**Re: SSD-73761707 Glendenning Road Data Centre – 2 Glendenning Road, Glendenning NSW
Response to Engineering Matters Raised by Conservation Programs, Heritage & Regulation
Group (CPHR)**

Further to the CPHR Advice (ref: DOC25/401585) relating to the Environmental Impact Statement (EIS) submitted for the above State Significant Development Application (SSDA), this technical memorandum has been prepared by ACOR Consultants Pty Ltd (ACOR) to respond to engineering matters within the CPHR advice.

Figure 2. Summary of Existing Topographic Survey Levels at Localised Sag Point

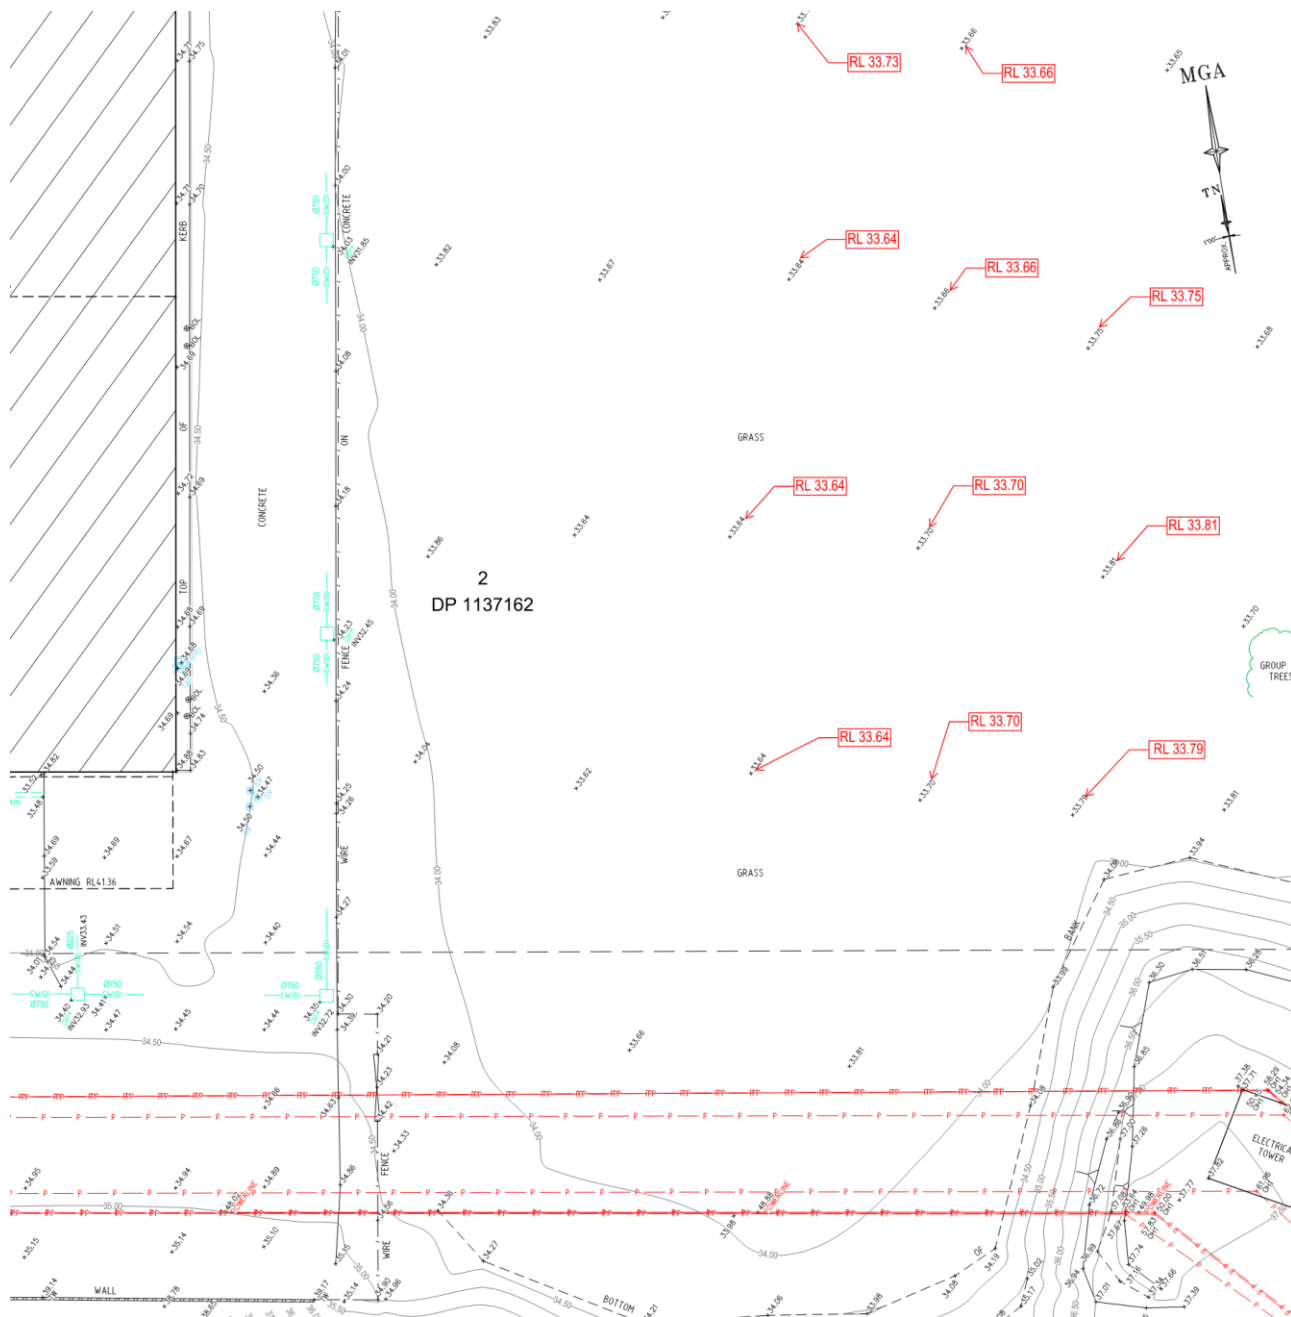
<p>1 <i>Flood Impact Assessment is not adequate</i></p>	<p>CPHR refers to Blacktown City Council's flood maps FloodBlacktown which shows the site is impacted by overland flooding in the 'Medium Risk Precinct' in the 1% Annual Exceedance Probability (AEP) event.</p>  <p>In addition, the site is impacted by Eastern Creek mainstream flooding in rarer flood events larger than the 0.2% AEP event. The depth of Eastern Creek flooding in the probable maximum flood (PMF) within the site ranges between 0.1 m to 0.4 m.</p> <p>The Flood Impact Assessment Report (FIA) is inadequate. The FIA includes discussion on existing flooding behaviour. However, no assessment for the post development scenario has been undertaken. No assessment for the impact of the development on flooding has been undertaken. No maps for existing, post development scenarios, or flood impact have been provided.</p> <p>Recommended action: The FIA is updated to assess the following:</p> <ul style="list-style-type: none"> consider the relevant provisions of the NSW Flood Risk Management Manual (2023) and associated guides, and Blacktown relevant Flood Studies for overland flooding and Eastern Creek address the full range of flood behaviour, flood constraints and risk for existing scenario for both overland flooding and mainstream flooding. To achieve this, flood behaviour would be examined for a range of events. Typical events examined may include the 10%, 5%, 1%, 0.5% or 0.2% AEP events and the PMF. The hydrological and hydraulic models developed by the consultant must be

A meeting with Blacktown City Council to assess flood impact comments from Council’s Engineering department was held on 18 August 2025. It is noted that Council’s concerns related to the portion of the site inundated by the 1% AEP flood event adjacent to the Endeavour Energy transmission tower, described as the “medium flood risk precinct”. The area of concern is shown in Figure 1 below.

The area of 1% AEP inundation is caused by localised sag points in the topography of the existing grass overing, causing isolated ponding in the TUFLOW model map outputs in the Blacktown Overland Flow Path Study. Figure 2 below illustrates the sag point causing isolated ponding of flood water based on the topographic survey data.

Figure 6. North-East Stormwater Outlet Position

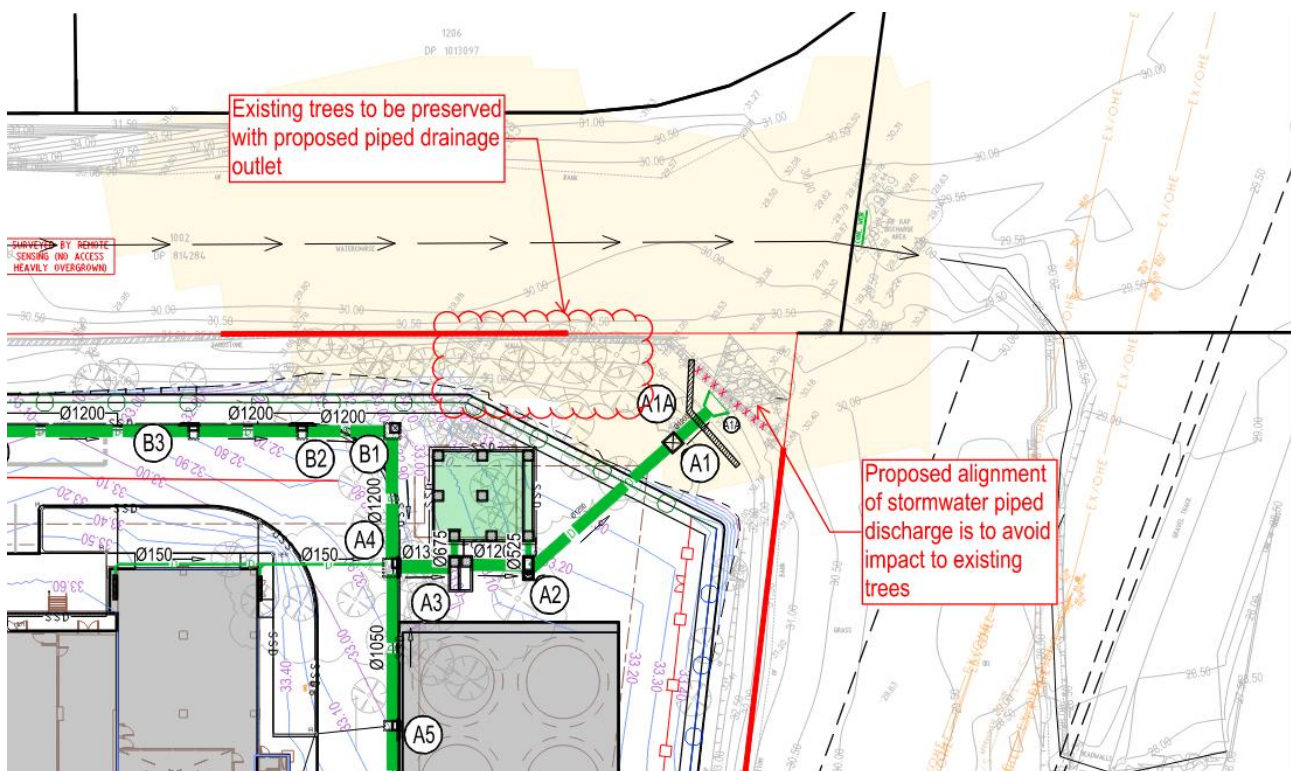
8. **Stormwater outlets – impacts** Two stormwater outlets are proposed along the eastern boundary. These outlets do not appear to connect into existing stormwater infrastructure or

waterway. Instead, they drain via a concentrated flow into the neighbouring land that is mapped on the [Biodiversity Values Map](#) and forms part of Nurragingy Reserve.
CPHR is concerned with the potential for erosion and pollution impacts over time past the proposed rock-armoured outlets, entering neighbouring land.
For the northeast outlet, there appears to be a nearby drainage channel that could be connected into. For the southeast outlet, no stormwater infrastructure appears to be nearby that could be used for a connection.

- Confirm if an easement is required to extend the northeast outlet into the existing drainage channel located on the neighbouring property to the north.

The north east stormwater outlet will discharge via headwall and scour protection to the northern drainage channel. The position of this outlet is to minimise impact to existing trees whilst keeping the outlet and scour protection within the subject site lot boundaries. Thus, extending or changing the position to drain into the drainage channel will have a larger environmental impact than the current design.

Figure 6 illustrates the impacts to existing trees if a shift in the stormwater outlet position is undertaken.

The scour protection for the north-east stormwater outlet has been designed to reduce outflow velocity to less than 1.0 m/s in accordance with Blacktown Council requirements. This will protect the downstream environment from scouring and erosion.

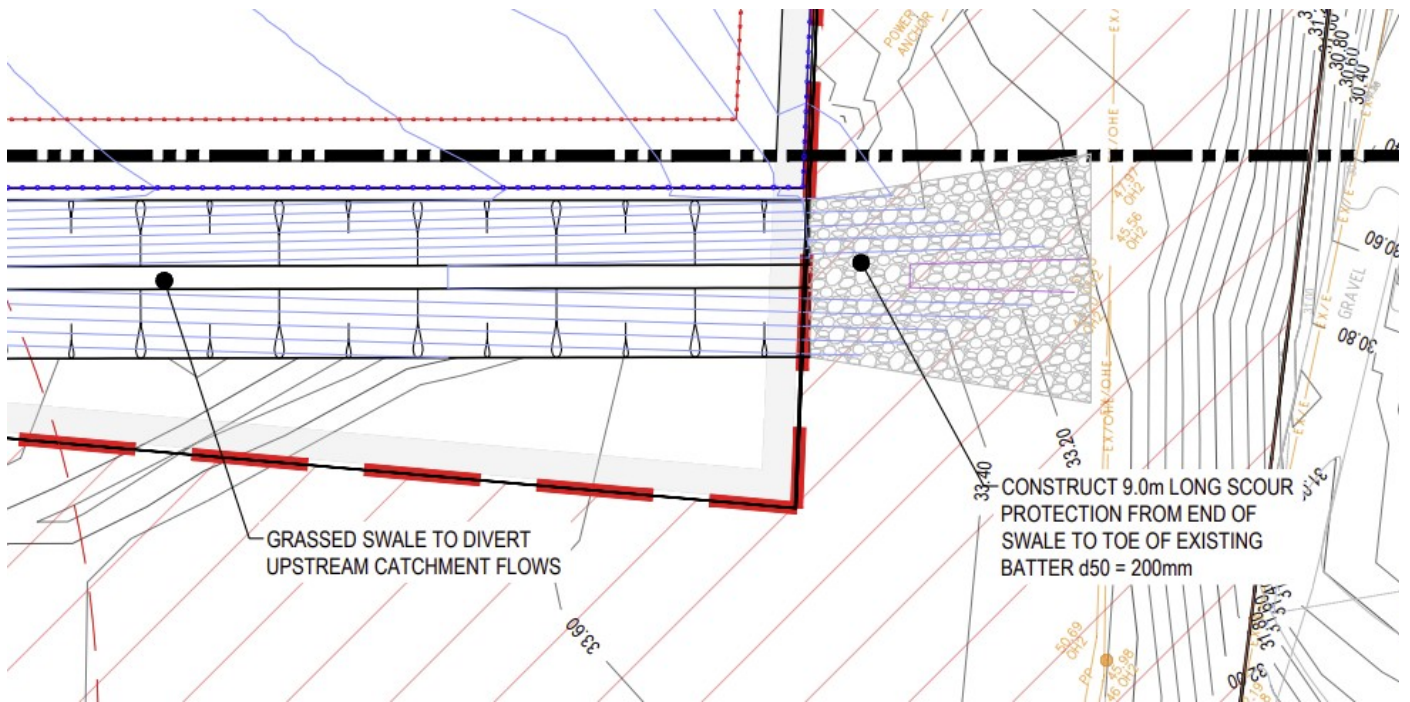
How will the excess water runoff through the scour protection be controlled, as not to cause future erosion of the track.

We have relocated the swale scour protections further to the west, so that the scour protection tail out is upstream to the existing 1V:6H vegetated batter.

The scour protection has been sized to spread the flows from the swale and reduce the velocities prior to travelling over the 1V:6H batter. The scour protection has been sized based on the *Catchments and Creeks* Publications, which we consider to be best practice.

The maximum outlet velocity at the end of the scour protection is **1.0m/s** for a partially vegetated batter of approx. 15% slope (ref: *Grass Linings – Drainage Control Techniques* by Catchments & Creeks)

- Recommended mean rock size (d50) for scour protection is 200mm
- Minimum length of scour protection required is 3.0m for a maximum depth 375mm swale (refer to Table 4 below)
- Actual scour protection length provided = 9.0m

The scour protection to be provided is shown in the image below and will reduce the flow velocities sufficiently to ensure that erosion downstream is not an issue. An updated civil works sketch can be resubmitted as required to reflect the below change in outlet structure.

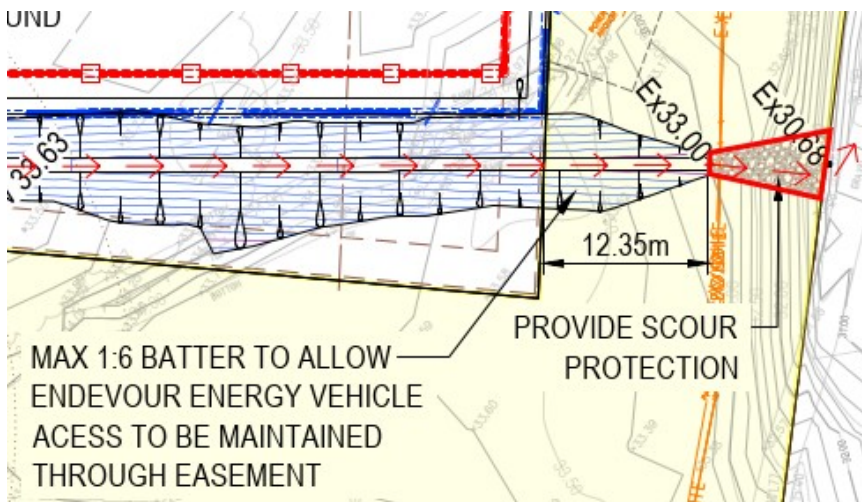
Endeavour Energy has identified that we have an easement access track located on the adjoining property as indicated below.
